SERVICE BULLETIN

Effective Date: MAY 2016
Log Number: 130
Subject: WATER SOLENOID VALVE 15° SLANT
Model Affected: 181GW

181GW - Solenoid With 15° Slant

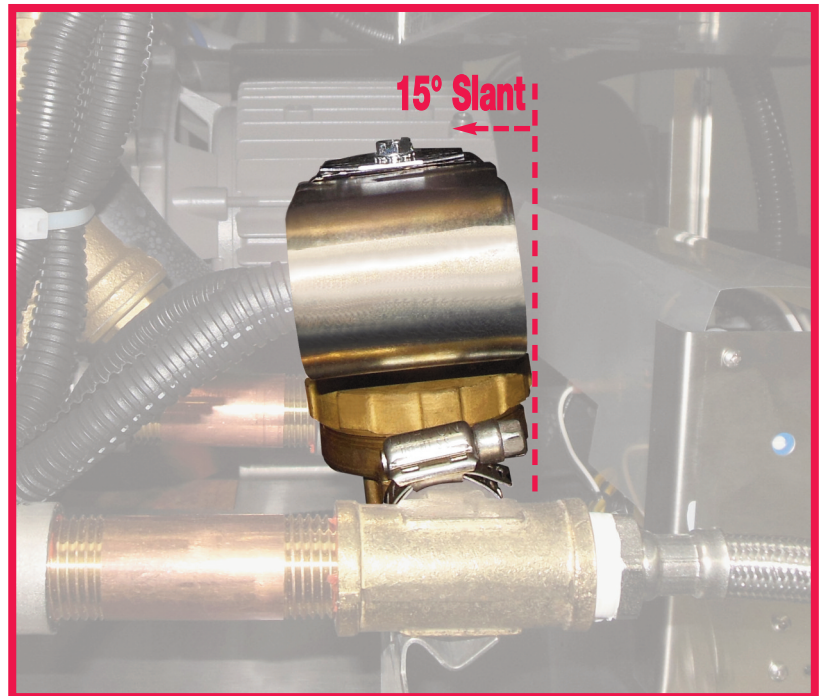
At CMA we continue to demonstrate our ongoing commitment to our Loyal Customers, Chemical Distributors, and Equipment Dealers by listening to their requests and suggestions. This latest modification to the angle of the Water Solenoid Valve (PN #03603.10) allows for easy access and removal of the Solenoid Coil on top to expose the debris screen for regular maintenance and cleaning.
